TECHNICAL MEMORANDUM

Prepared by: Tom Myers, Ph.D., Hydrologic Consultant, Reno NV

Re: Review of Phase 2 Ground-Water Investigation Report for the San Mateo Creek Basin Legacy Uranium Mines Site

Figure 1: North-south hydrogeologic cross-section along the San Mateo Wash. The cross-section shows the Homestake Mill on the left (southern portion of the cross-section) and the confluence of the Arroyo del Puerto and upper San Mateo Creek on the north. Source: Figure A2-3 from EPA (2018)

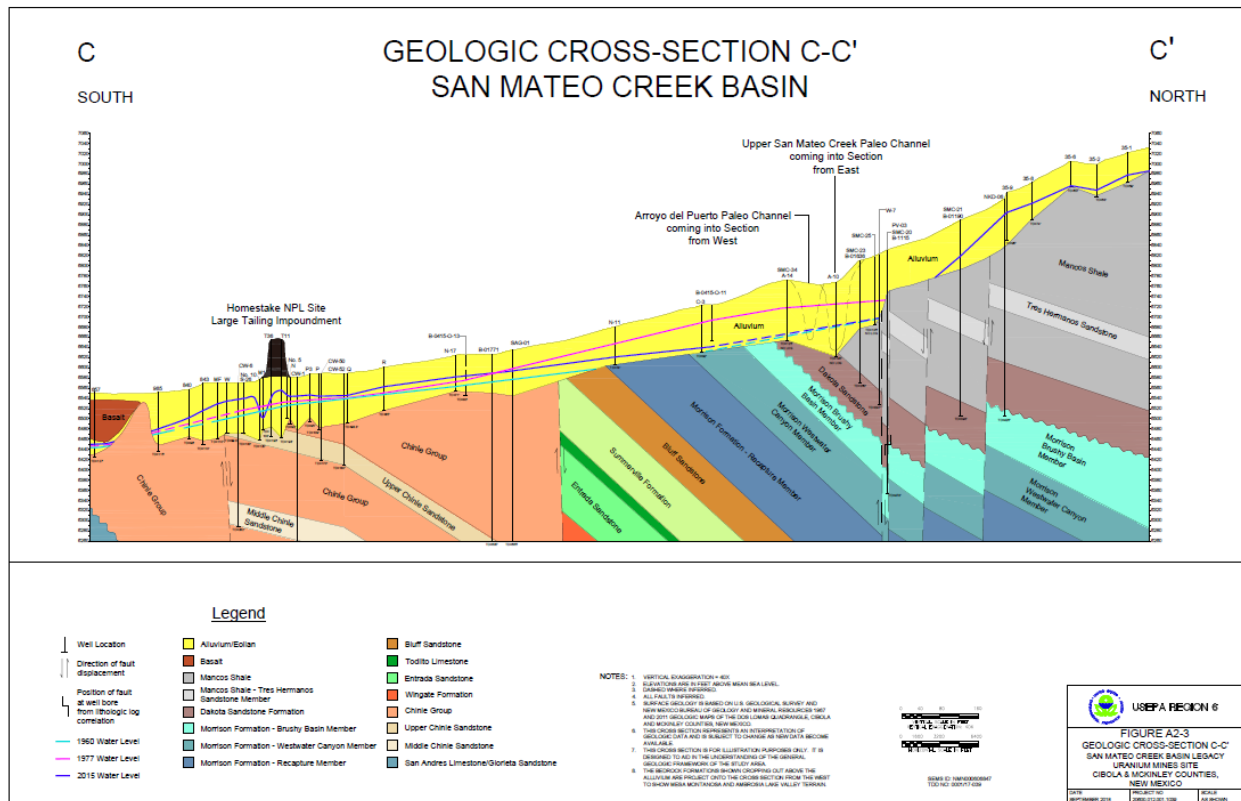
The hydrogeologic cross-section along the San Mateo Wash indicates the primary pathway for water from the Ambrosia Lake area to mix with groundwater near the Homestake Mill, including in the Chinle and alluvial formations, is through surface water or through the alluvium (Figure 1). The downward dip of the formations north of the Chinle would not be conducive for bedrock flow anywhere other than into the alluvium if there is enough head in the bedrock. The fault between the Chinle and other

bedrock formations might inhibit downgradient flow from the Upper Basin, even if the fault enhances vertical flow at the fault contact. The San Mateo fault generally parallels and coincides with the section in Figure 1. The cross-section also shows water levels in 1975 much higher than in 1960 or at present. The report directly acknowledges that seepage from the Homestake mill recharged and contaminated the underlying Chinle water-bearing sandstone units where they subcrop to the alluvium (p A4-2).

Figure 2: Alluvial saturation shown in blue for 1960. Source EPA (2018) Figure A4-2

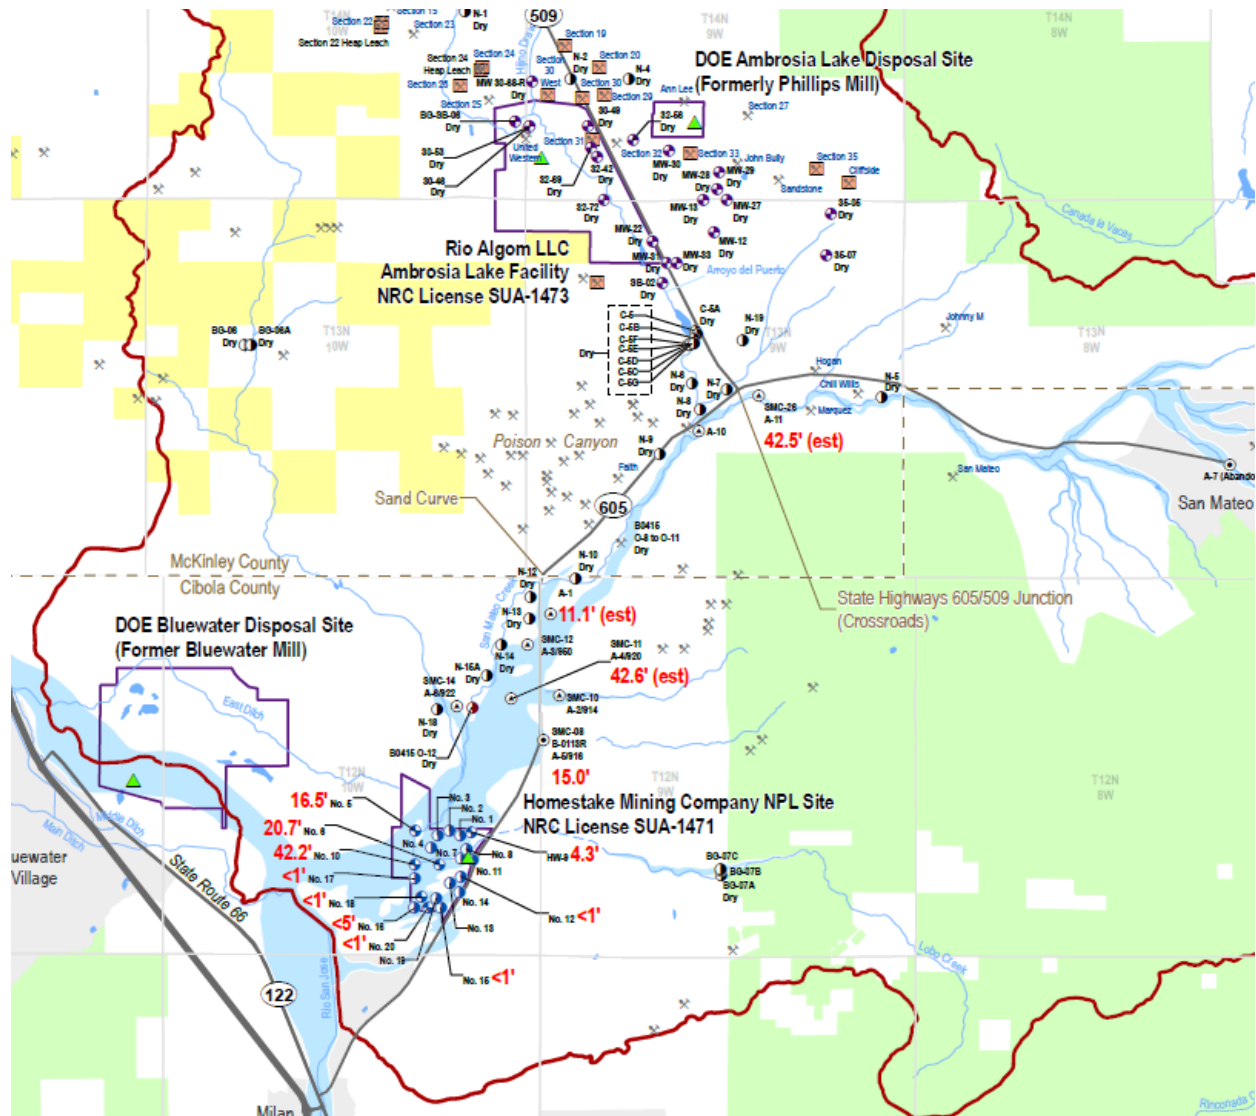
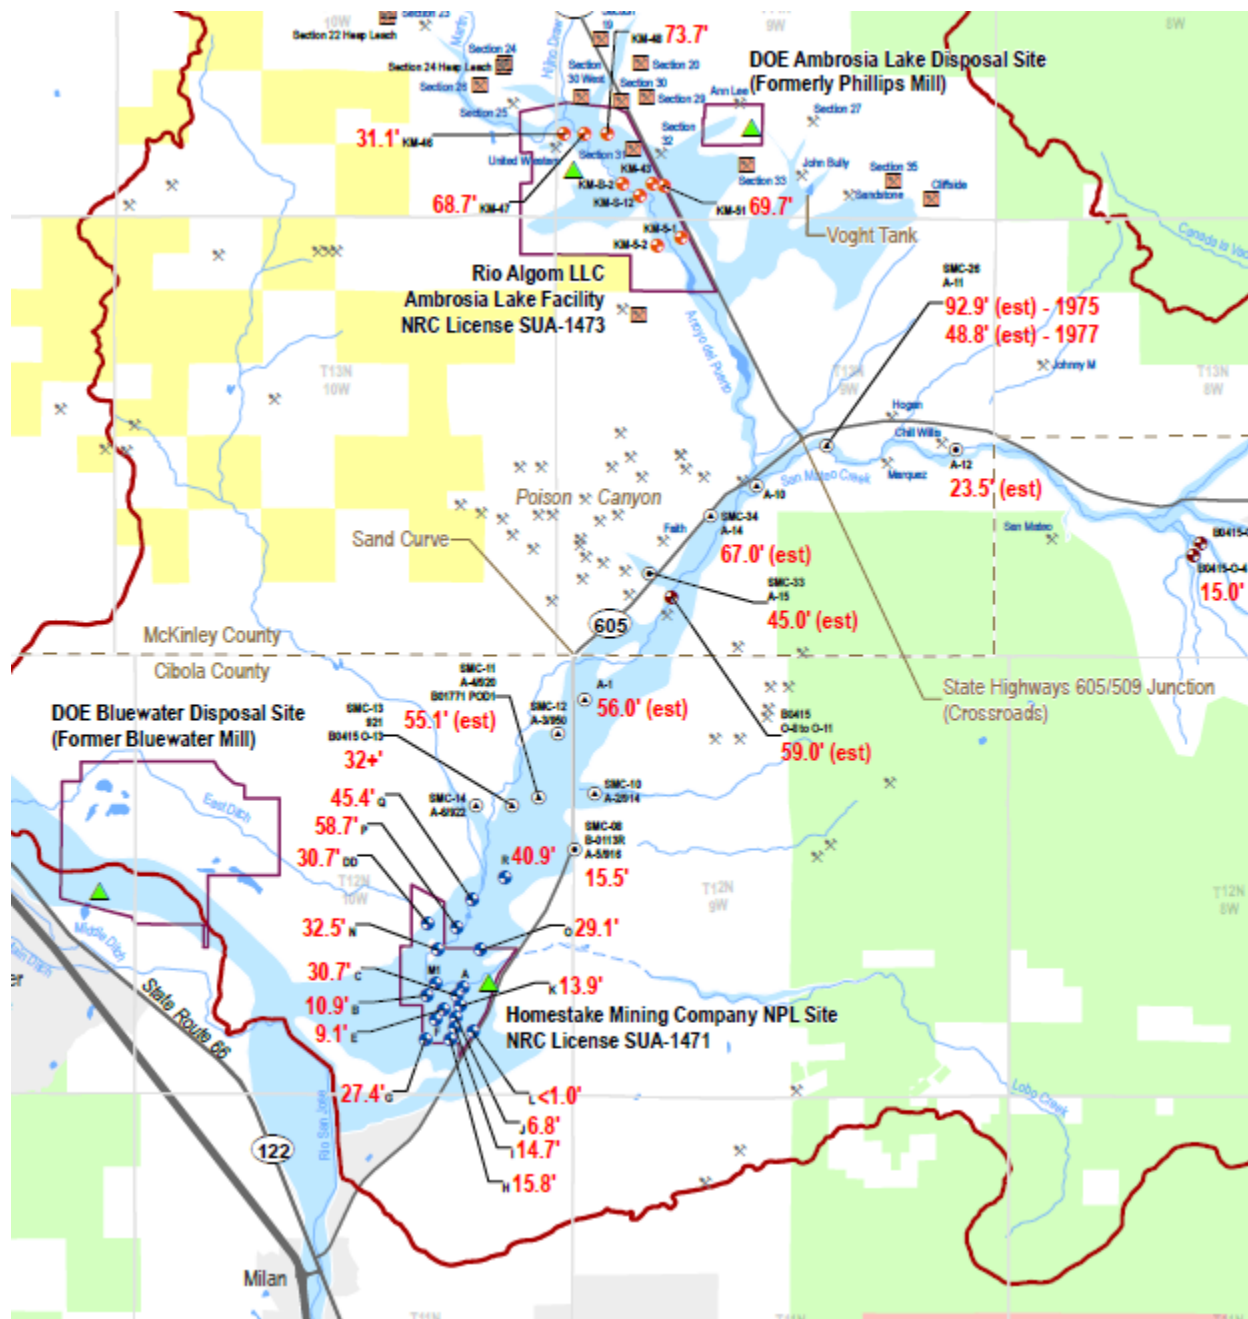
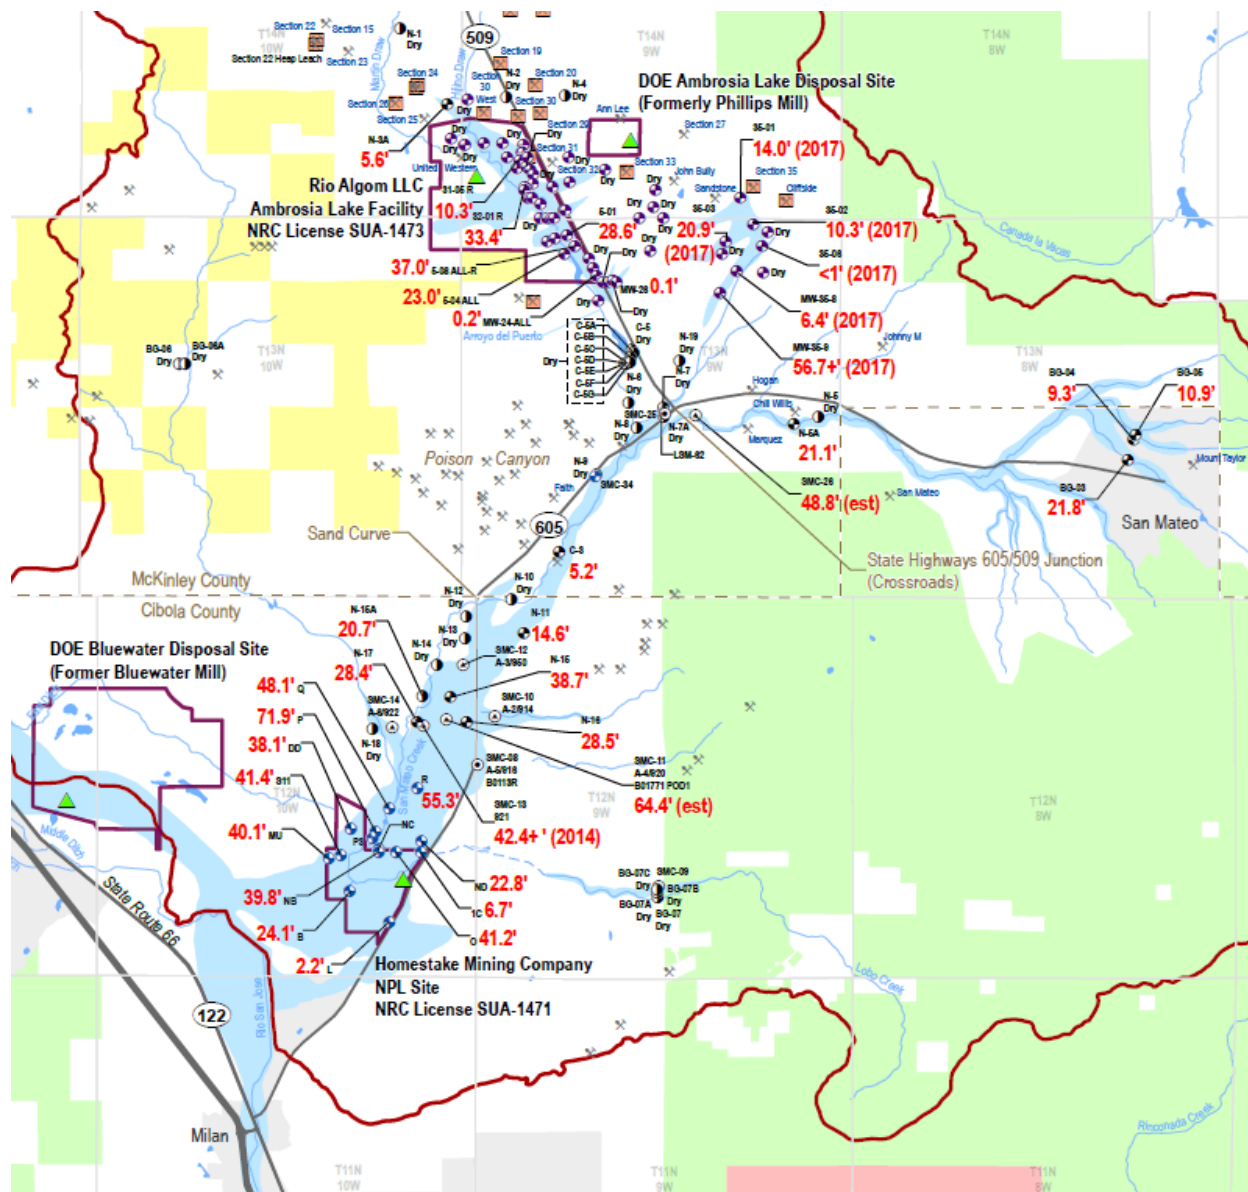
The report documents the evolution of the level of saturation in the alluvium from 1960 (Figure 2) to 1975-77 (Figure 3) to 2015 (Figure 4). In 1960, the San Mateo Creek alluvium was saturated from about the town of San Mateo through the confluence with Arroyo del Puerto and Sand Curve to south of the Homestake Mill, but there was no saturated alluvium in the Ambrosia Basin (Figure 2). In 1960, the

The figures also indicate the saturated alluvium south of the LTP grew since 1960. The blue saturated area covered a smaller area southwest of the LTP in 1960 (Figure 2), than in the 1970s (Figure 3). The saturated thickness would also have increased commensurately. In this area, the millsite seepage was most responsible for increasing the saturation in the alluvium.

Figure 5: Alluvial groundwater elevation and spot changes between 1960 and 1975 in the lower San Mateo Basin. Source: EPA (2018) Figure A4-9

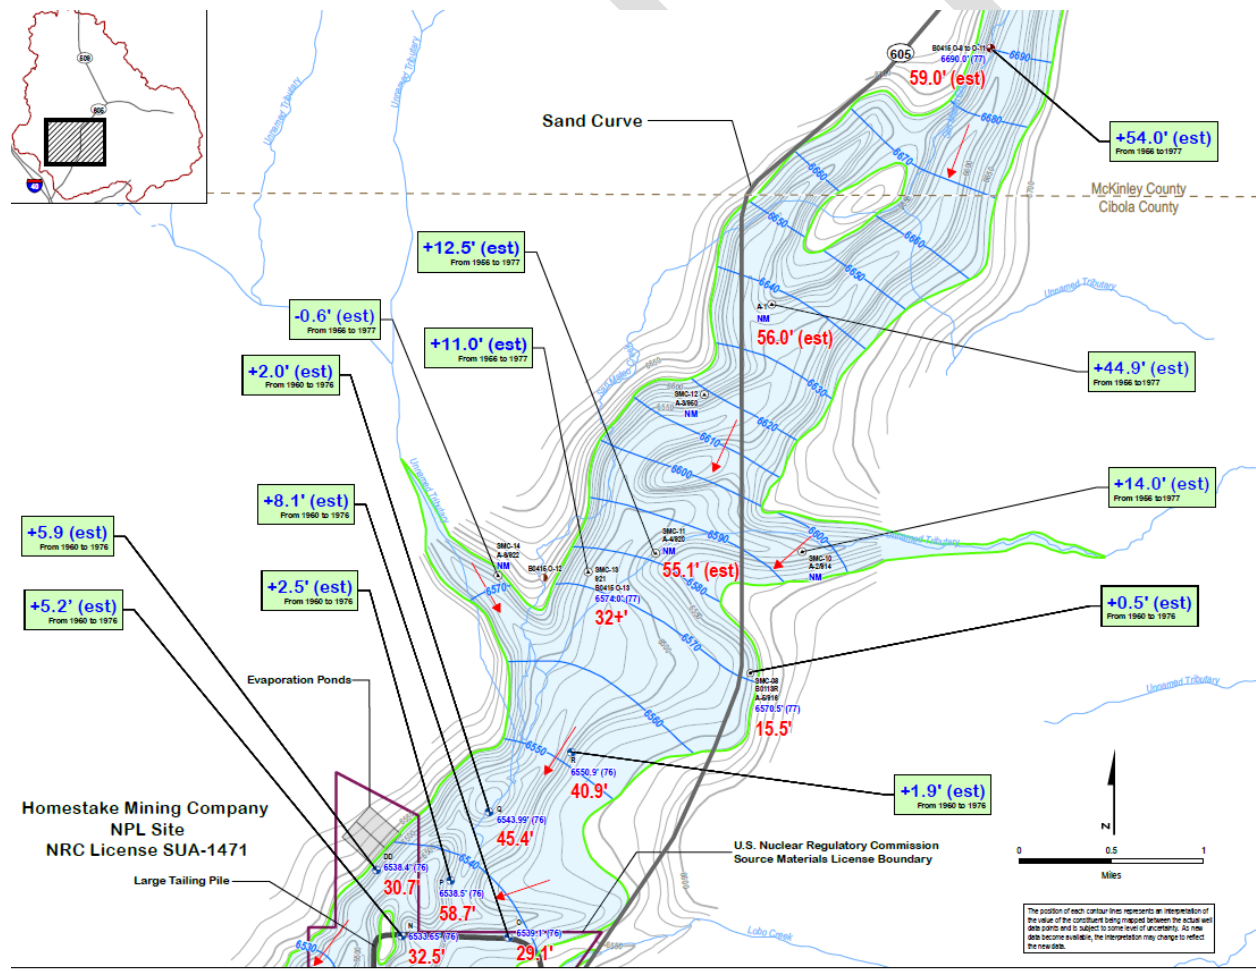
The groundwater level in the lower San Mateo Basin increased from 1960 to 1975 and the aquifer increased in width (Figure 5). Compared with Figure A4-8, groundwater levels increased from over 50 feet near the confluence to a couple feet between Sand Curve and the Homestake Millsite (the numbers in green boxes in Figure 5 show the change between 1960 and 1975). One reason the increase in groundwater table and saturated thickness is so much more upstream near the confluence could be the narrowness of the alluvial channel which causes the groundwater to pond in that area. It could also be that a wave in the groundwater was passing through the confluence and was only beginning to reach the channel near and south of Sand Curve. The report would have to include a series of maps through the 1980s to determine whether this explanation is possible.

Groundwater levels near the LTP have increased more than they increased further upstream even though there is no obvious difference in the alluvial channel area that would cause ponding at that

point. This increase near the LTP visible in 1975 could be the beginning of a mound forming beneath the LTP, as hypothesized by Myers (2015) as a means of a short-distance gradient reversal to cause U to move from the LTP seepage northeast against the general flow through the alluvium. The development of a mound would be easier to assess with a series of maps through the 1980s.

Figure 6: Alluvial groundwater elevation and spot changes between 1975 and 2016 in the lower San Mateo Basin. Source: EPA (2018) Figure A4-11

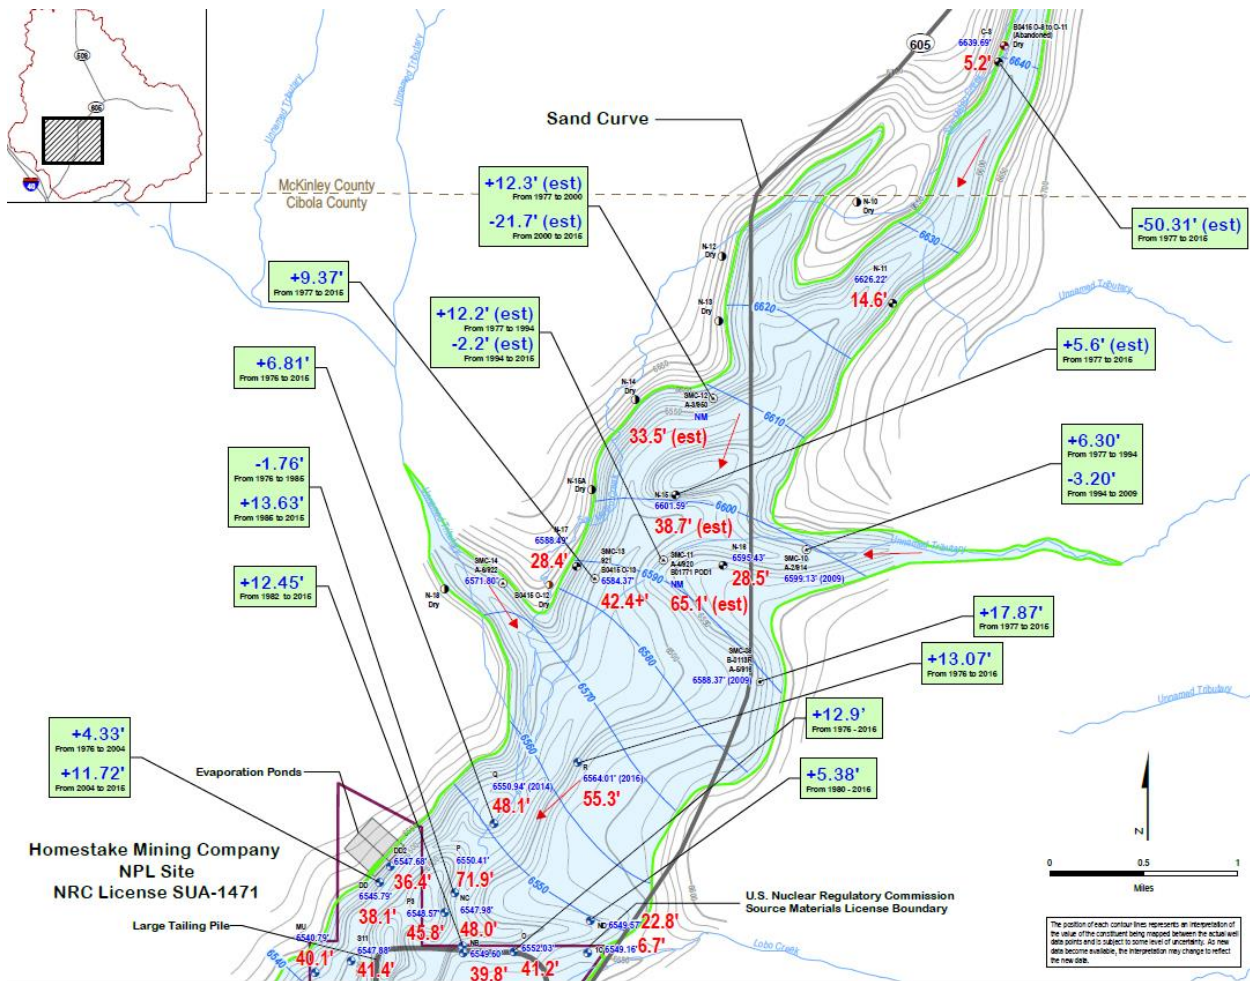
Groundwater elevations and the changes between 1975 and 2016 show the movement of a groundwater slug from the confluence through Sand Curve toward the LTP (Figure 6). Groundwater levels decreased over 50 feet at the point furthest north, in the confined bedrock channel (well C-3). Further south overall changes were much less although some wells show that a higher groundwater elevation was attained in the 1990s after which either a substantial decrease occurred (well SMC-12) or, further south, most increase occurred before the 1990s and since the decrease has been slight (wells SMC-11, SMC-10). Further south near the LTP, the increase has simply continued (where there were readings in the 1990s, more groundwater level increase has occurred since then). This effectively describes a slug moving through the alluvium in the bedrock channel, with the mounding under the LTP damming the groundwater flow. Although the alluvium has effectively desaturated from the Sand Curve to the north since the 1970s, the saturated thickness has increased since then south of Sand Curve.

Figure 7: Uranium concentrations in the alluvium of the Lower Basin. Source: EPA (2018), Figure A4-12.

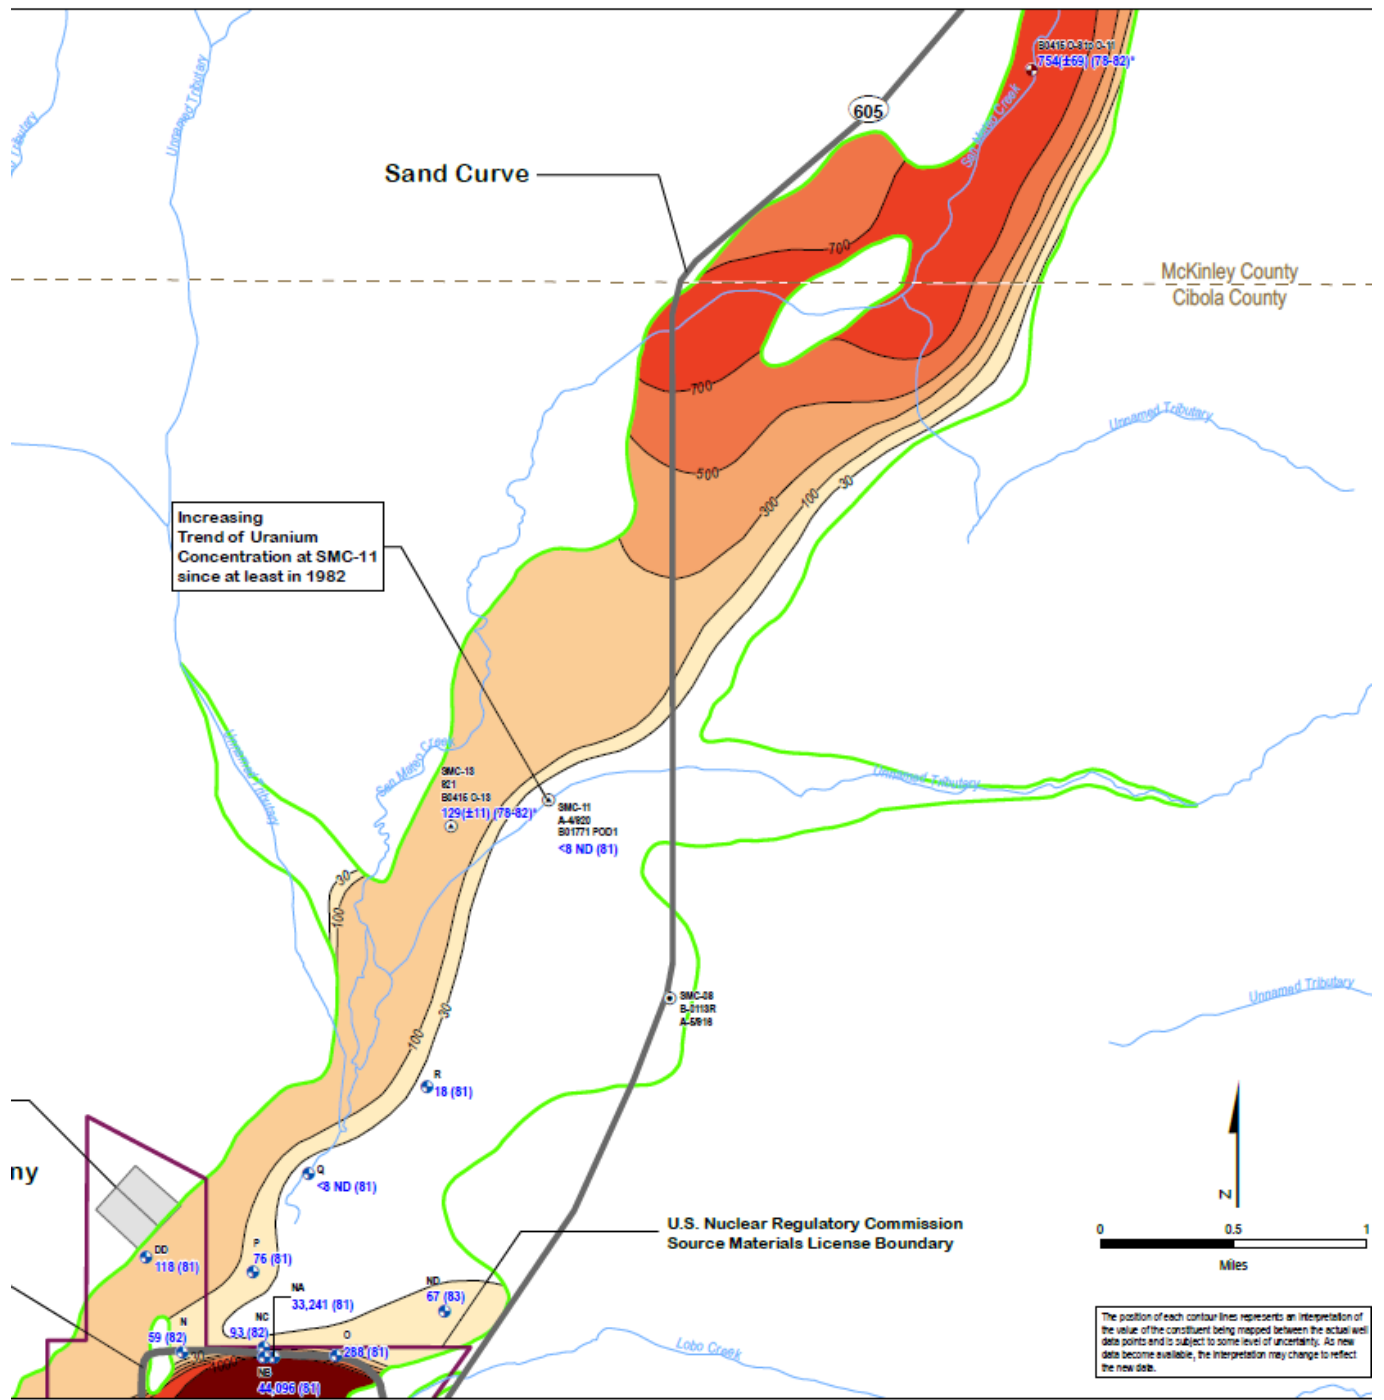
U plume maps for the 1970s and the mid-2010s show the movement of U downstream along the San Mateo Wash, showing the movement of a plume from the Crossroads area to near Sand Curve (Figures 7 and 8). However, the 1970s plot is based on too little data. There is only a cluster of observations averaging 0.754 mg/l; however, the 0.7 mg/l contour extends south along the channel particularly in the deeper paleochannel on the west side (Figure 7). The report notes the “elongated and narrow plume of higher uranium concentrations extending from the northern boundary of the map to the southern boundary of the map along the western margin of the SMC paleo-channel” (p A4-17). Because SMC-13 has U at 0.129 mg/l, there must be a gradation between the points, but the report cites no data to support drawing the 700 ug/l plume so far southwest along the paleo channel. However, the DD well in the paleochannel near northwest of the LTP has U at 118 ug/l while the concentrations nearer the LTP are much lower. This observation supports the concept of a plume moving southwest in the paleochannel.
